J2126A-08

S E R V I C E N O T E

Agilent J2126A Transmission Test Set

Incorrect operation of Signal Wizard at STM-0 due to incorrect fitting of resistors

Location of R725 on J2125-63003 Board

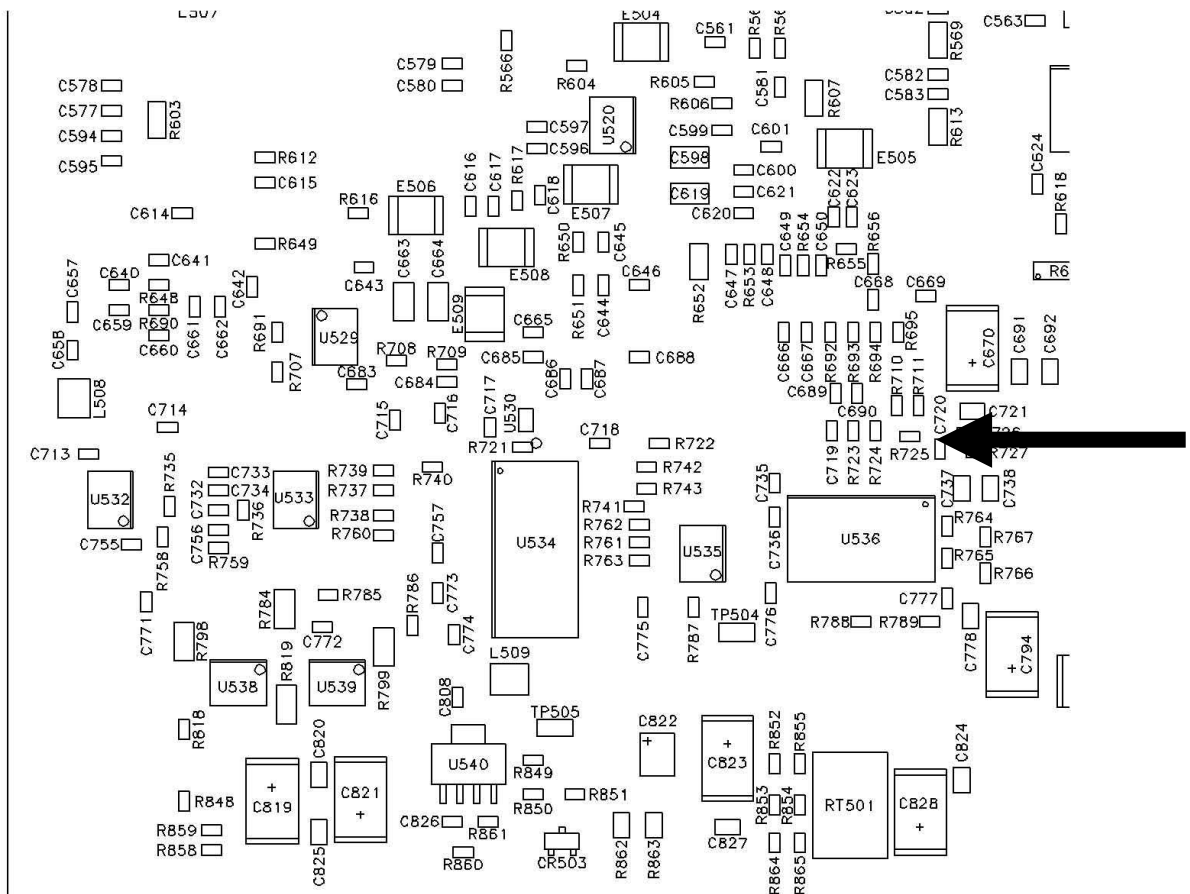
A batch of instruments were shipped with the wrong value resistors fitted to the Digital Board (p/n J2125-63003). This causes incorrect operation of the instrument's Signal Wizard feature at the STM-0 signal rates. All other signal rates are unaffected.

1. Remove the instrument top panel by unscrewing the four corner screws.
2. Lift off the instrument top panel.
3. Remove the Digital Board. The board is the rear-most board in the instrument cardcage.
4. Locate resistors R725 and R797. Use the following illustrations as a guide.

5. Replace R725 with 100 ohm resistor 0699-3924 and resistor R797 with 0 ohm resistor 0699-3574.
6. Replace the Digital Board and instrument covers by performing the reverse of steps 1 to 3. Ensure the screws on the cover are tightened to a torque of 0.15Nm maximum. Ensure the screws securing the instrument top cover are tightened to a torque of 2.8Nm
7. End of procedure.
